OFFICE MEMORANDUM

SUBJECT: ADDITIONAL DISPOSAL WELLS IN AREA C

DATE: September 17, 1963

*Cross section of cement lined
Disposal Well*

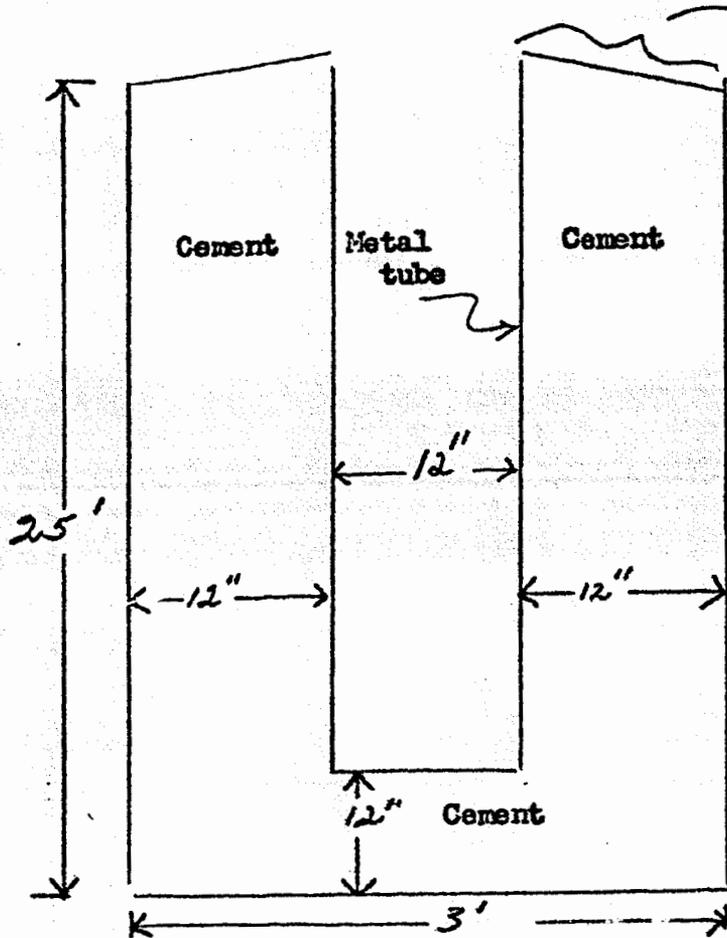
NOTE: Cement lining to be finished at top of well so as to promote water drainage away from well. Suggest at least 1 inch slope.
